City of Portland  
Development Review Application  
Planning Division Transmittal Form

**Application Number:** 2015-080                      **Application Date:** 05/14/2015  
**CBL:** 113 A025001                                      **Application Type:** Level III Site Plan Under 50,000 sq f  
**Applicant:** Bangor Savings Bank                      /Wendy Durrah  
**Project Name:** Bangor Savings  
**Address:** 20 MARGINAL WAY  
**Project Description:** Three Story, 2,100 Square Footprint bank/office with a double drive thru at 20 Marginal Way in Portland.  
**Zoning:** B7

Project Name: **AMENDMENT re entrance design;  
Bangor Savings Bank Bank/Office building with two lane drive-through**  
Project ID: #2015-080  
Address: 20 Marginal Way CBL: 113 A 025001  
Applicant: Bangor Savings Bank  
Planner: Jean Fraser

Bank/Office Building with Bank Drive-through, 20 Marginal Way  
Level III Conditional Use and (Level II) Site Plan  
Bangor Savings Bank, Applicant  
Project #: 2015-080  
CBL 113 A025001

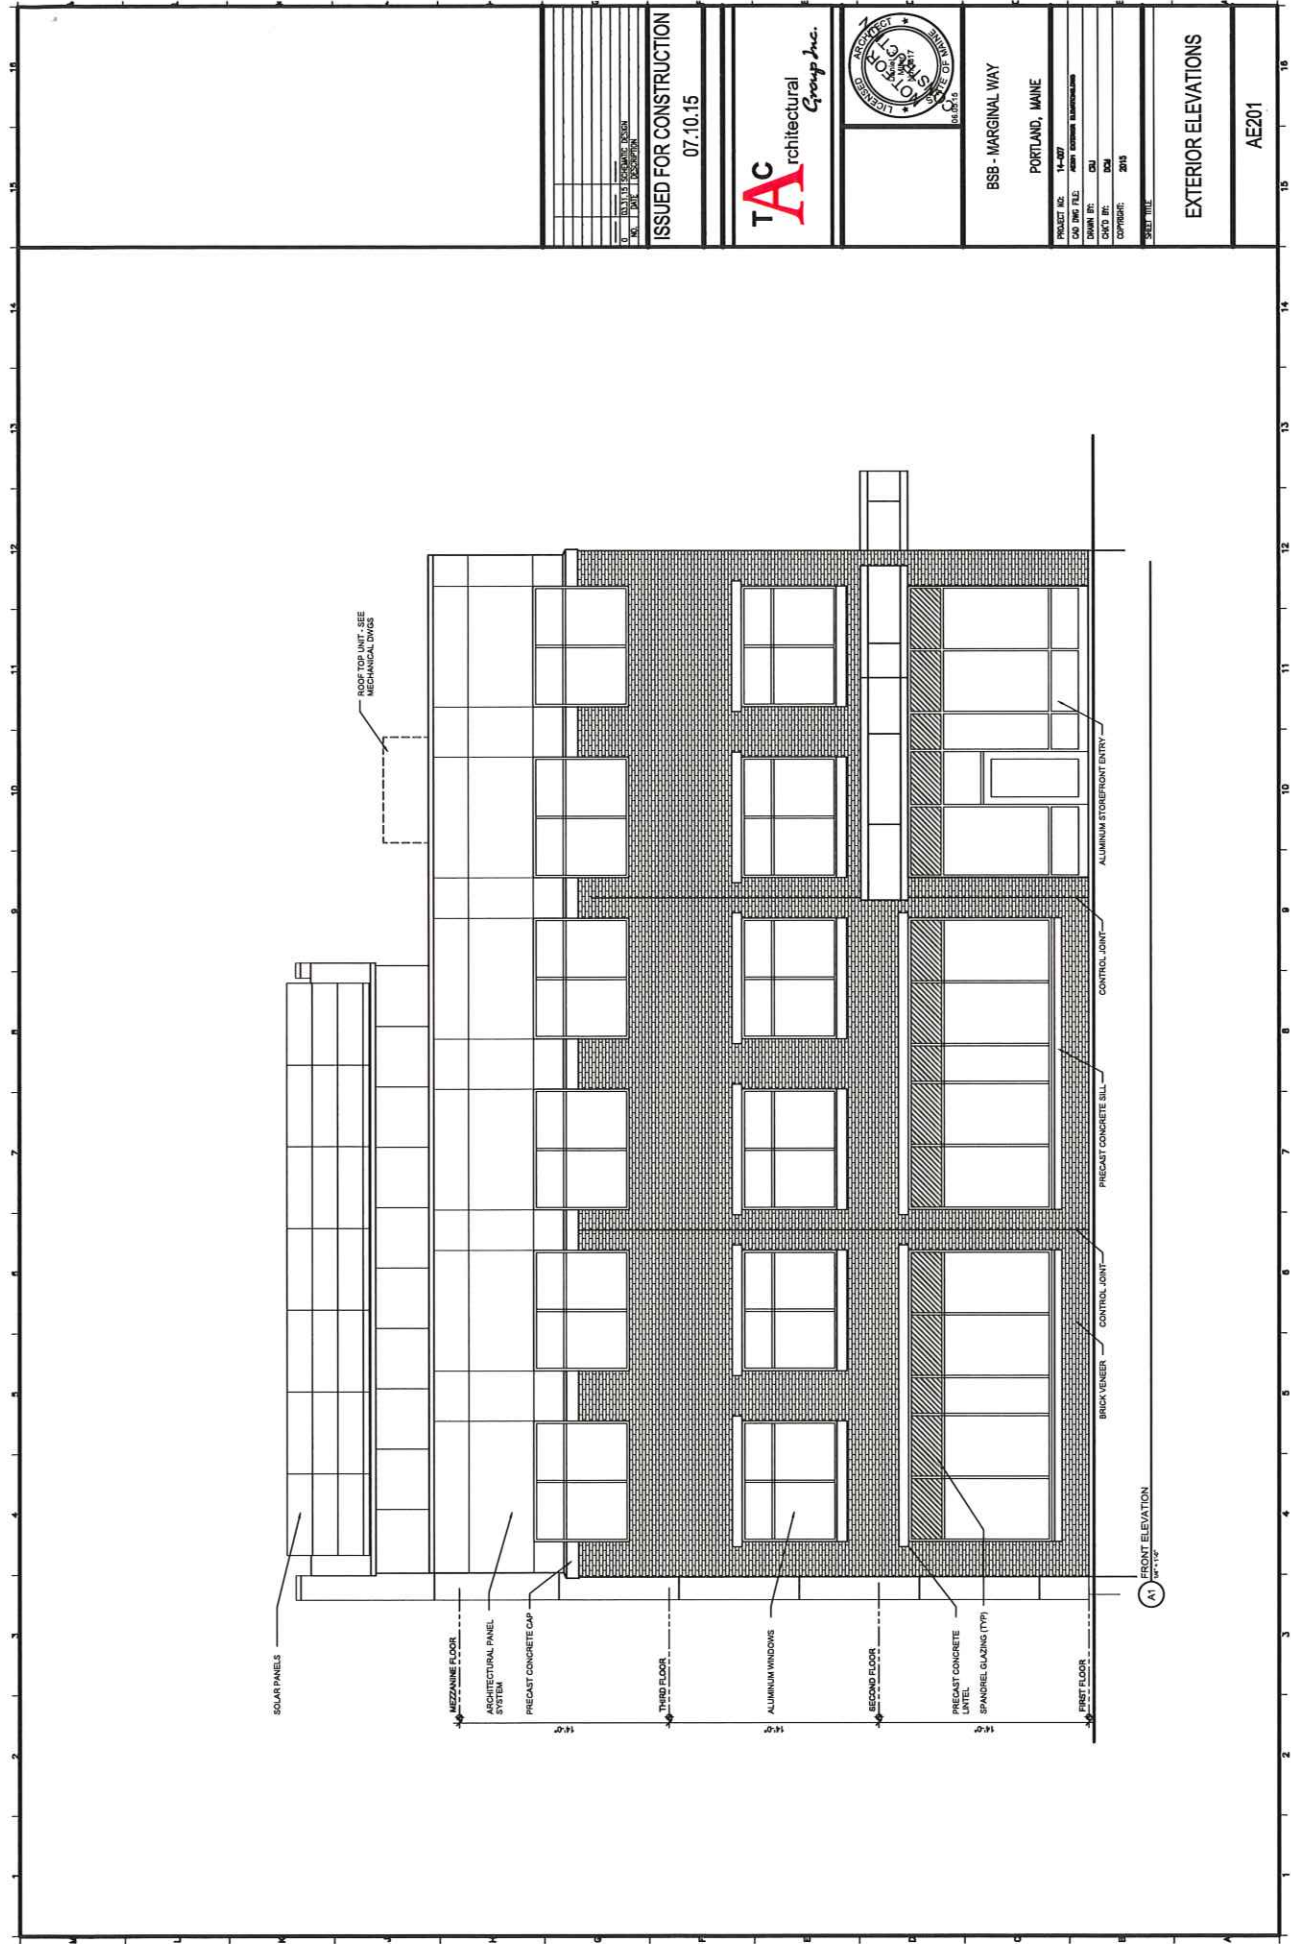
I am confirming that for 20 Marginal Way, Condition of Approval iii. regarding the glazing has been met with the following agreement:

- Building elevations remain the same
- Glazing for entire building shall be Solexia + Solarban 60 with a VT of .61 and which has a slight green tint. The lower Visible Transmittance and slight green tint are allowed as a compromise for better energy performance in the building and with the understanding that interior shades will not be used.
- Spandrel glass shall be used on the transom section of storefront on the first floor only (as shown in the elevations) to mask the floor plate behind.
